RENESAS TECHNICAL UPDATE

| Product Category | MPU & MCU | | Document No. | TN-RX*-A111A/E | Rev. | 1.00 |
| Title | Corrections to User's Manual regarding the FASR.EXS bit for the Flash Memory in the RX111 Group | | Information Category | Technical Notification | | |

This document describes corrections to the description for the FASR.EXS bit in section 35. Flash Memory of RX111 Group User's Manual: Hardware Rev.1.10.

Figure 35.16 Procedure to Issue the Start-Up Area Information Program Command/Access Window Information Program Command

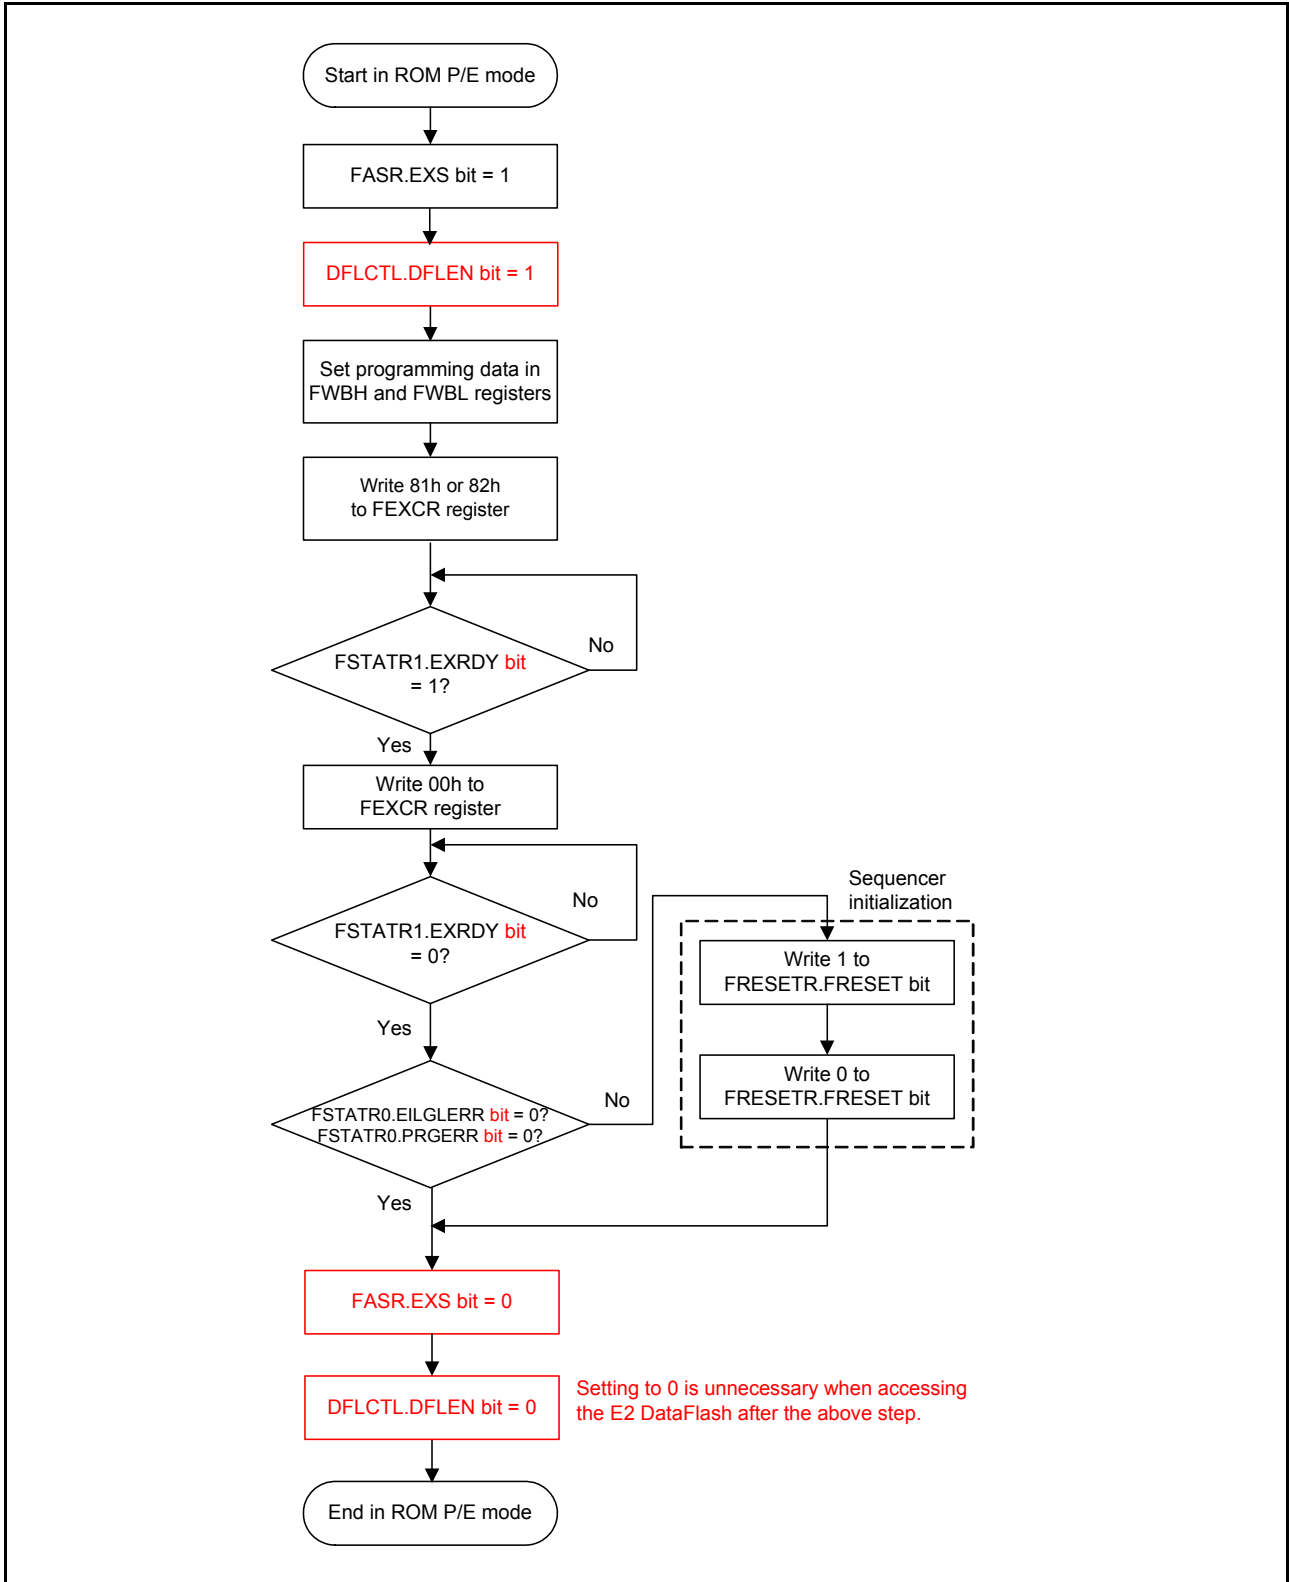
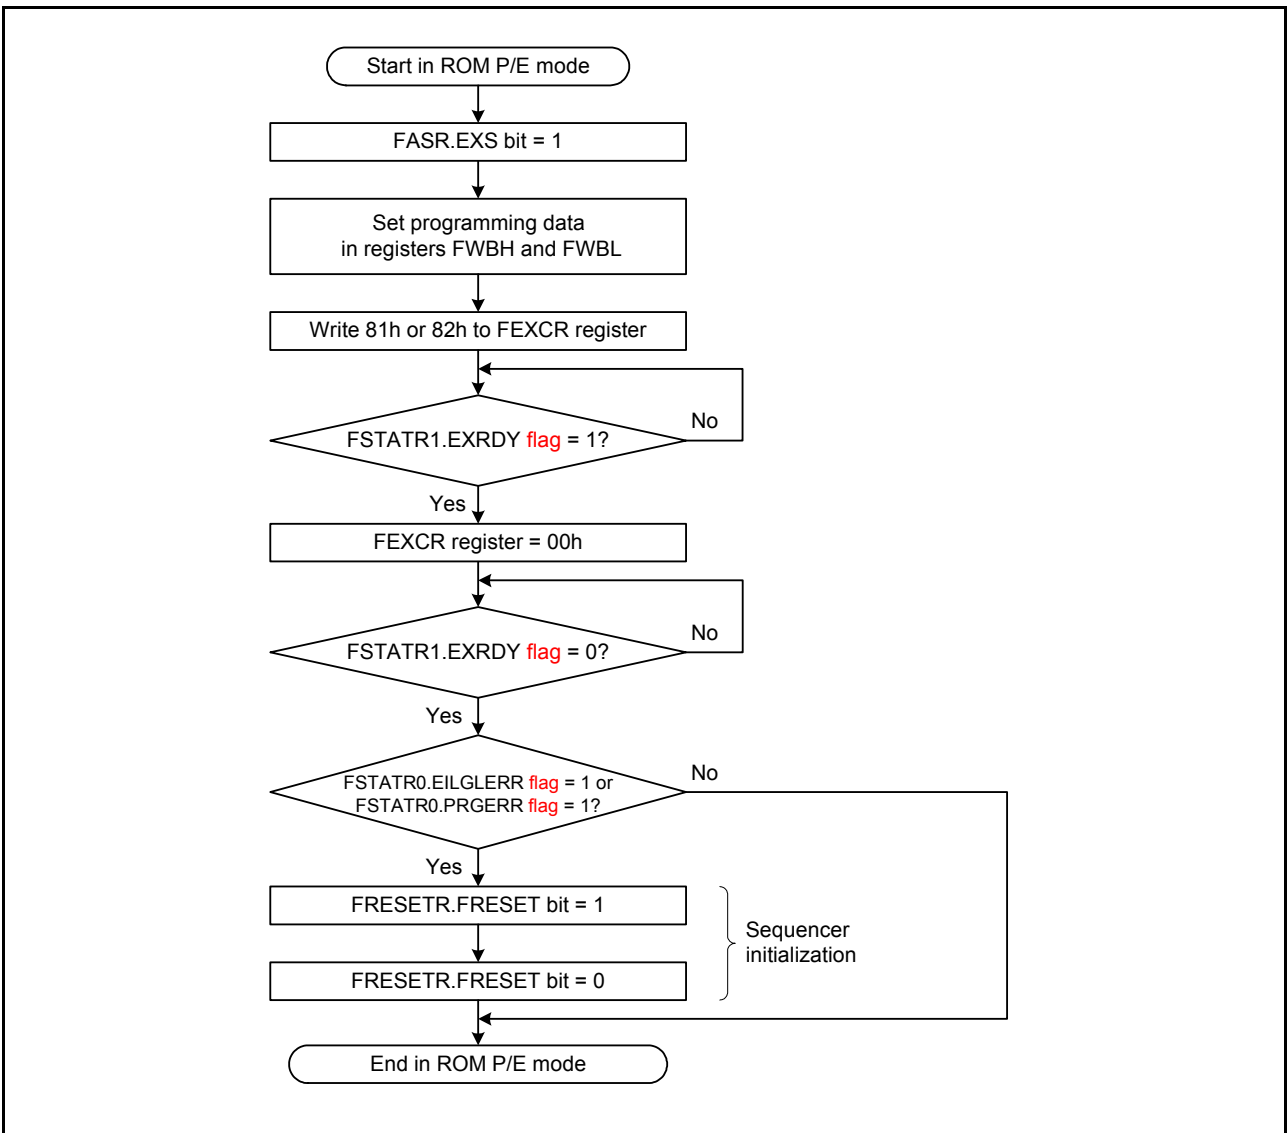
Figure 35.16 in (4) Start-Up Area Information Program/Access Window Information Program of 35.7.3 Software Command Usage is corrected as follows:

Figure 35.16 shows the procedure to issue the start-up area information program command and access window information program command. When the sequencer has directly entered ROM/PE mode from E2 DataFlash access disabled mode, set the DFLCTL.DFLEN bit to 1 at the beginning of the procedure.
